DOCUMENT 00 90 00
ADDENDUM

ADDENDUM No.: 1

DATE: September 19, 2024

RE: VIROQUA HOUSING AUTHORITY
PUBLIC HOUSING PROJECT WI 118
200 PARK VIEW COURT
VIROQUA, WI 54665
PROJECT NO. 24012

1 THIRD FLOOR PLAN
1/8" = 1'-0"

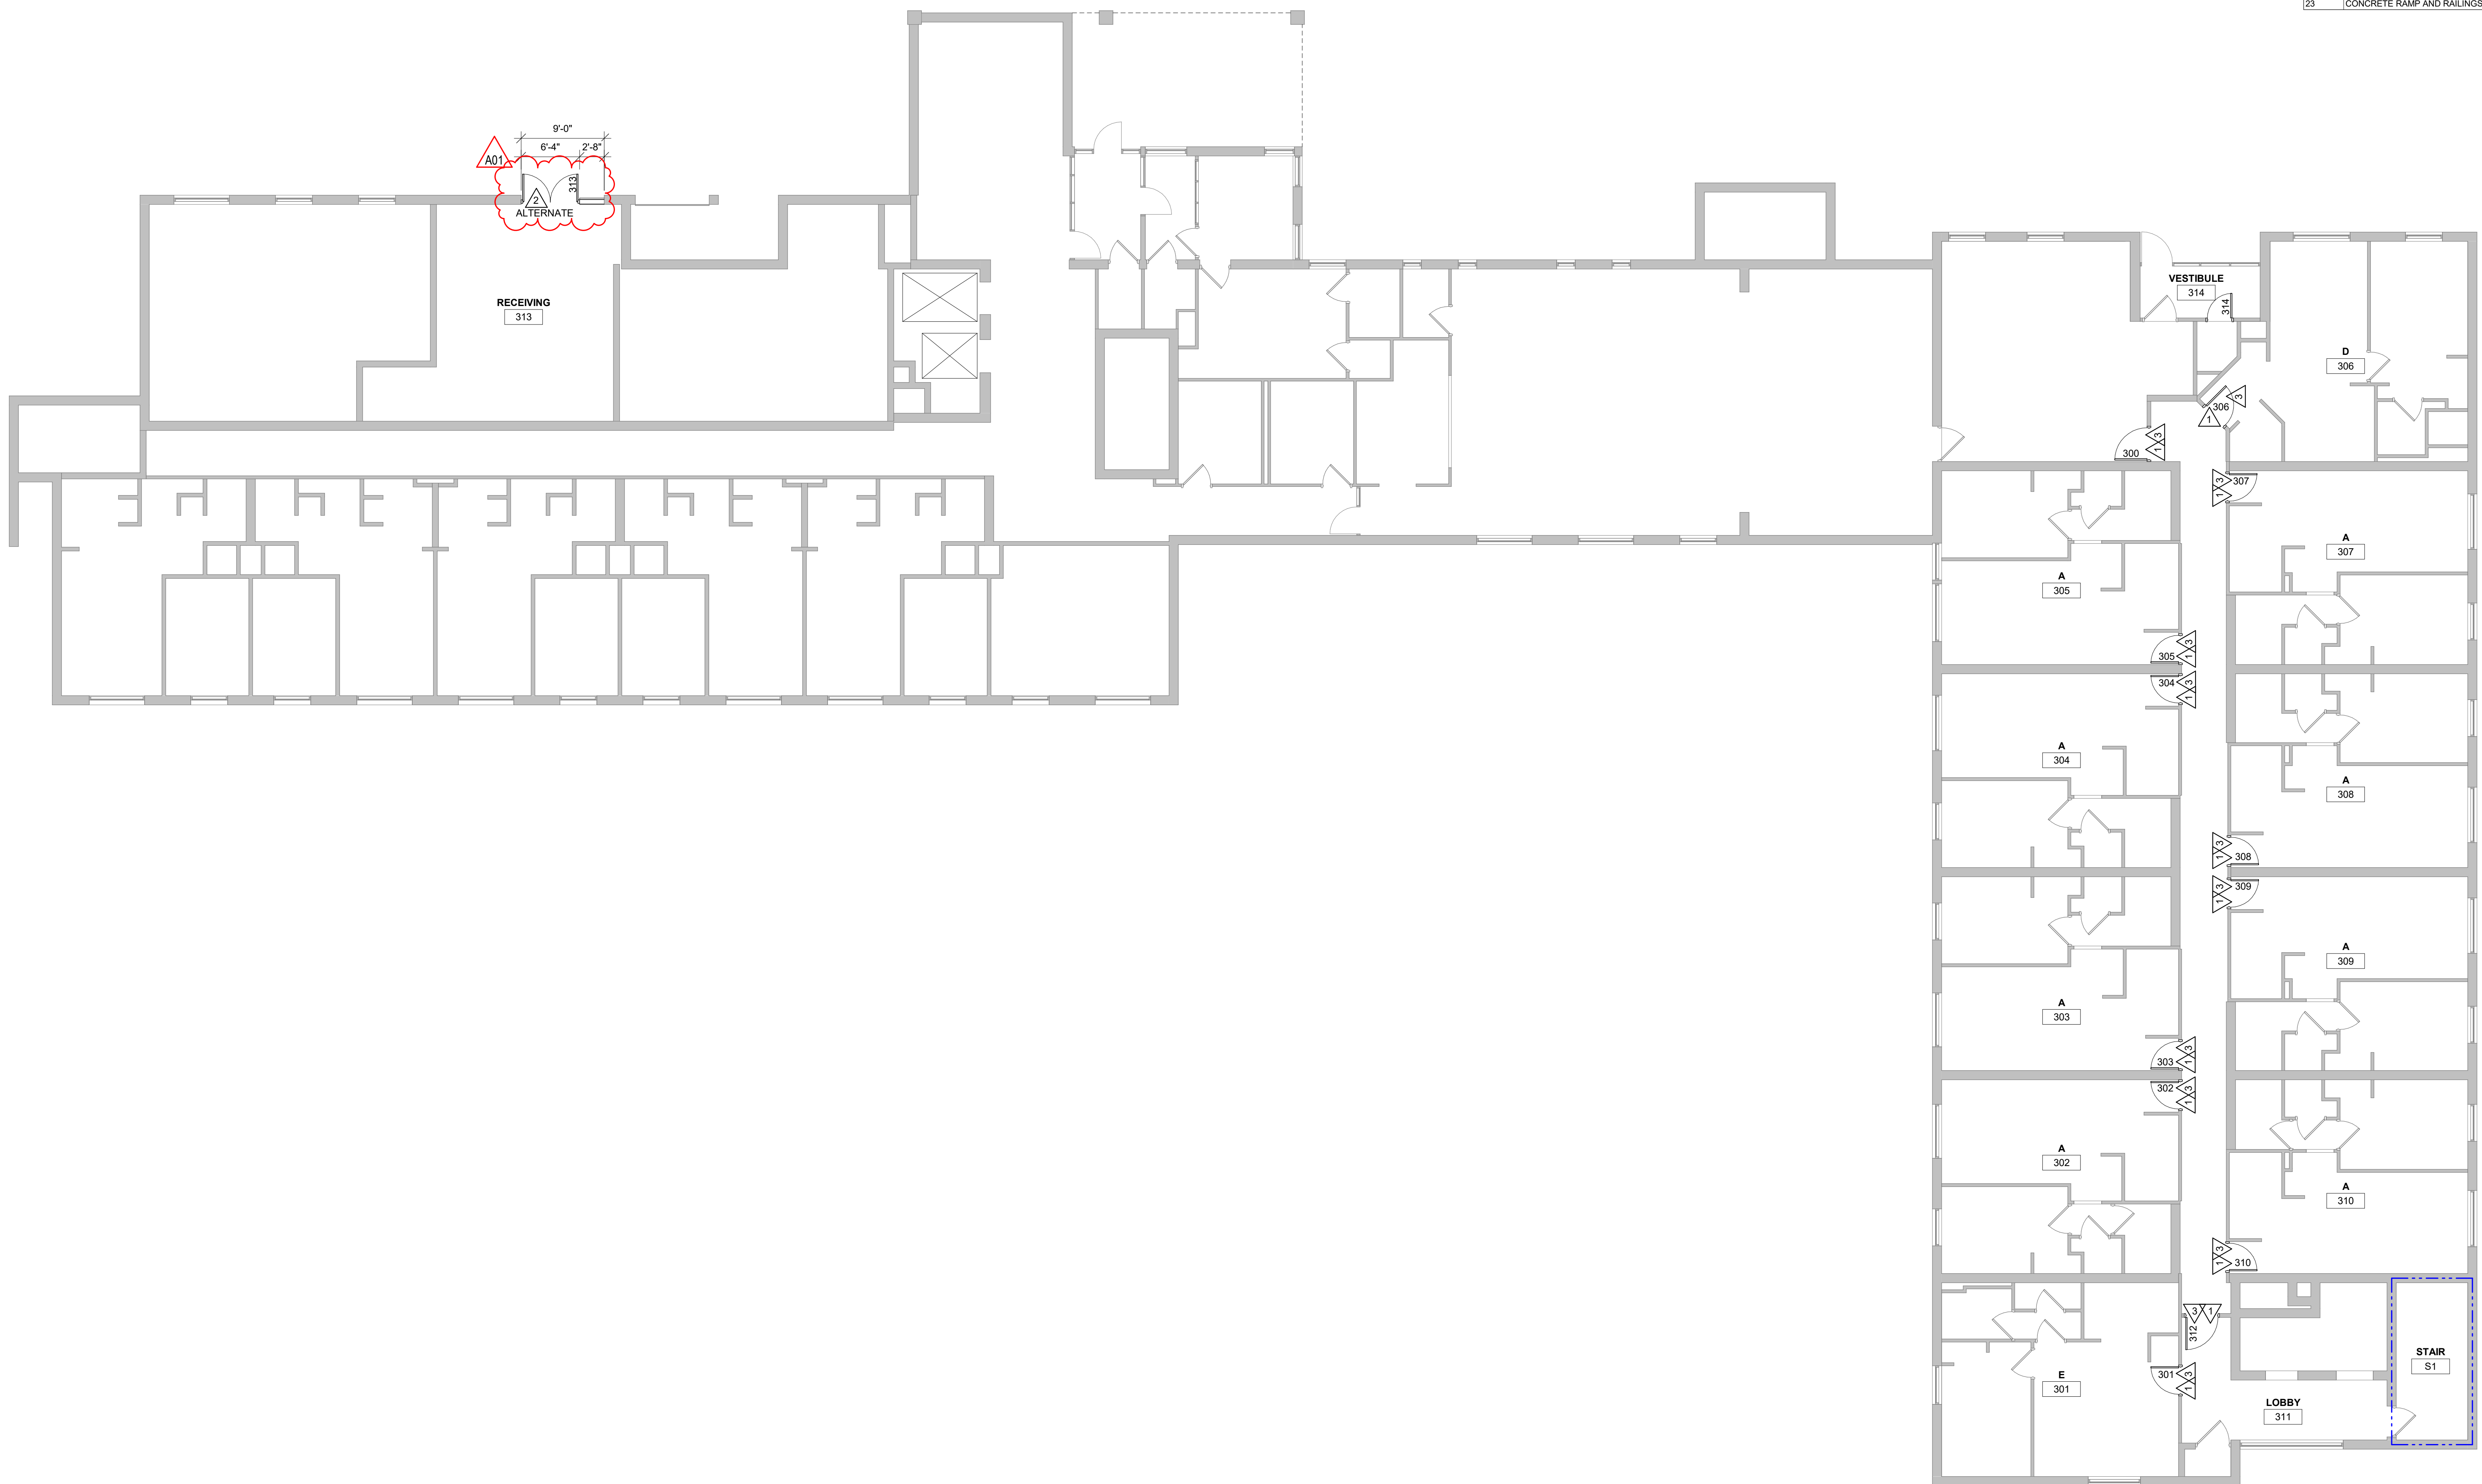
- a. See the revised sheet included in this addendum. Disregard the previous version.
 - b. Redesignated door 313 as alternate.
11. Sheet A110 MAINTENANCE SHOP PLANS 30"x42"

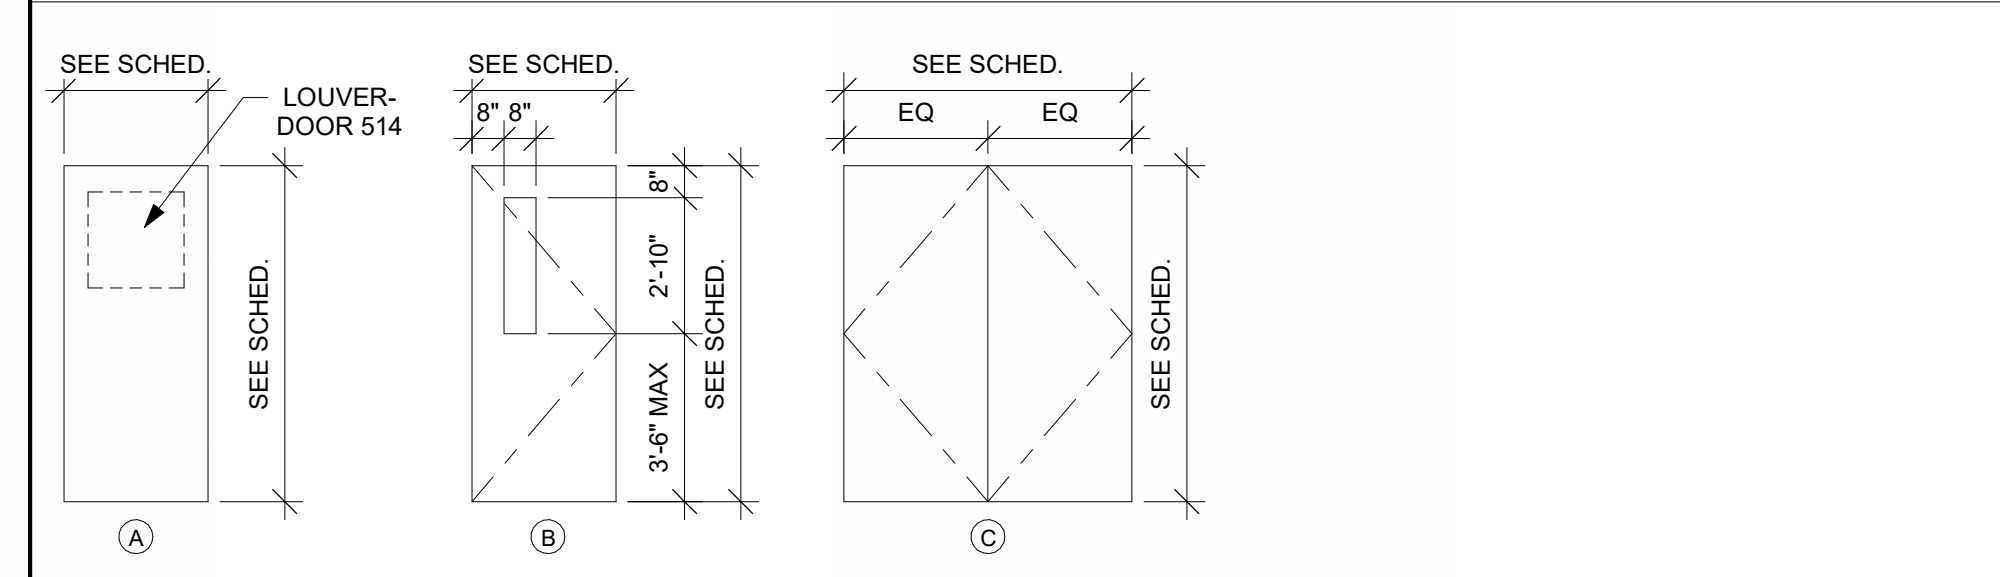
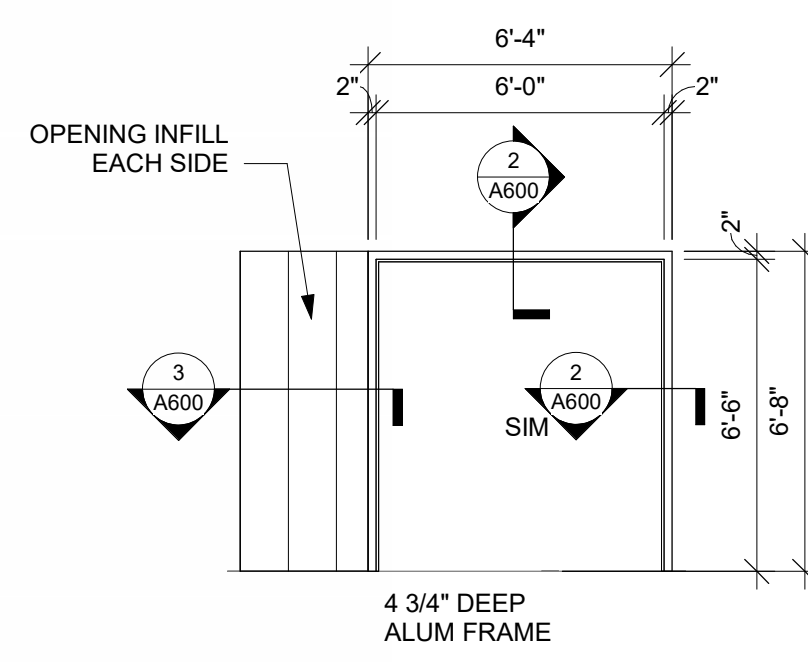
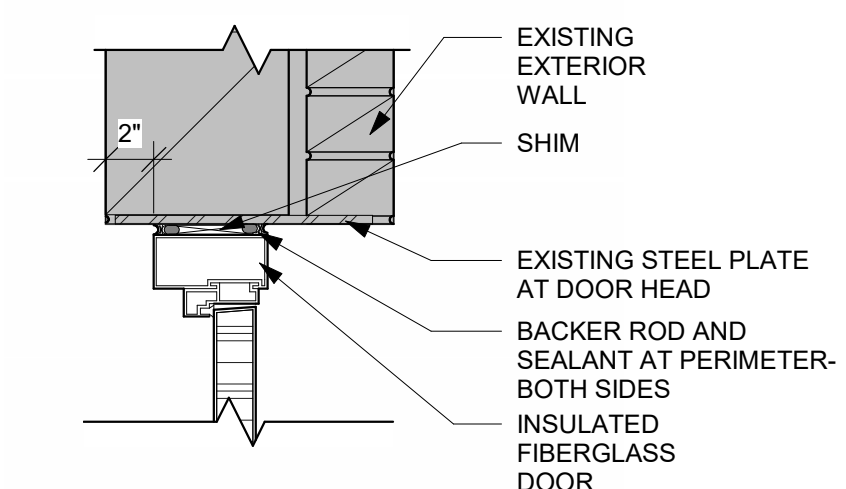
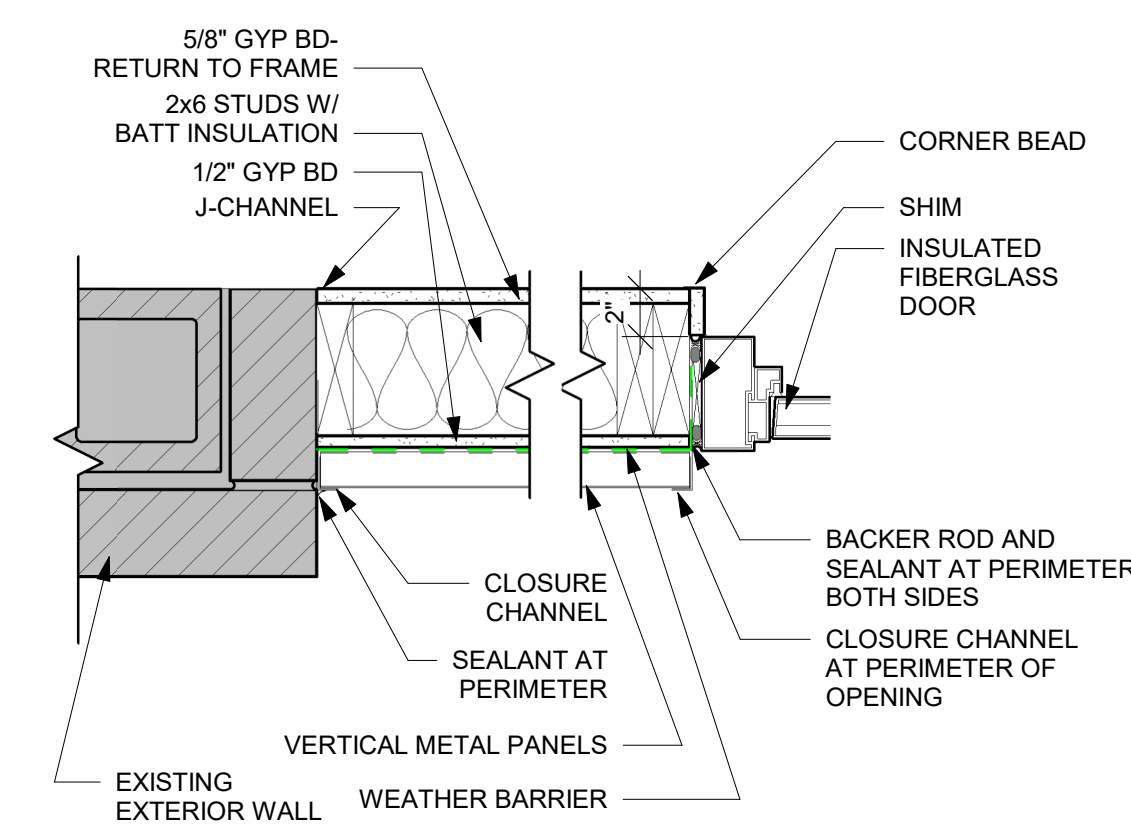
- a. See the revised sheet included in this addendum. Disregard the previous version.
 - b. Redesignated door 313 as alternate.
 - c. Added photo of existing room signage / identification plate.

- d. Revised Door Schedule General Notes and Door Schedule Remarks.
13. Sheet E100 ELECTRICAL PLAN 30"x42"
 - a. See the revised sheet included in this addendum. Disregard the previous version.
